Re: Notice of Site Visit Findings and Proposed Actions Pursuant to Sections 301(a) and 402 of the Clean Water Act: 2015 MSGP Tracking Number PRR053093

The following presents AES-PR's response to EPA findings noted during the **Facility walkthrough**:

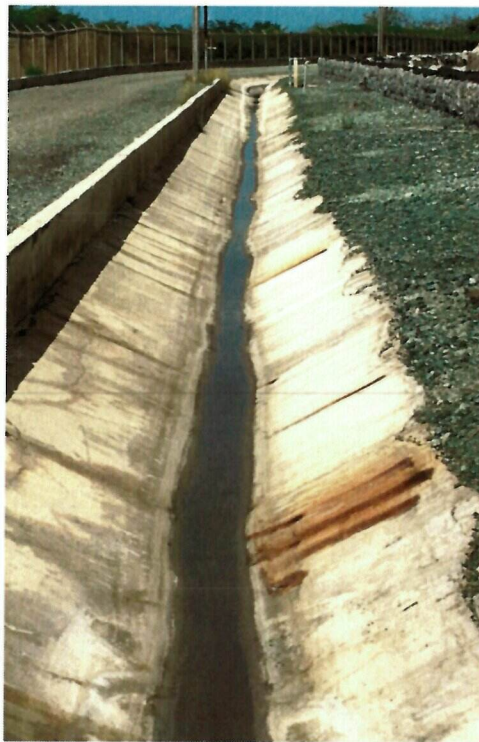
- A portion of the concrete storm water conveyance ditch located at the south side of the Agremax pile was observed covered with Agremax.

- *The concrete storm water conveyance ditch shall be cleaned to allow for free/uninterrupted flow.*

AES-PR Response: The ditch section was not "covered" with Agremax. This portion of the concrete storm water conveyance ditch contained Agremax that by design had been settled out of the storm water runoff from the Agremax stockpile that is carried by the conveyance. This is part of normal operations as further explained below.

AES-PR Response: The concrete storm water conveyance ditch has a secondary sediment retention function performed by in-stream check dams that pool the water and restrict flow to settle out suspended solids, and therefore an accumulation of sediment in the ditch is expected as part of its routine operation. This ditch is cleaned periodically when necessary, often at the end of the work shift. The sediment accumulation observed during the walkthrough was cleaned in accordance with our customary practice.
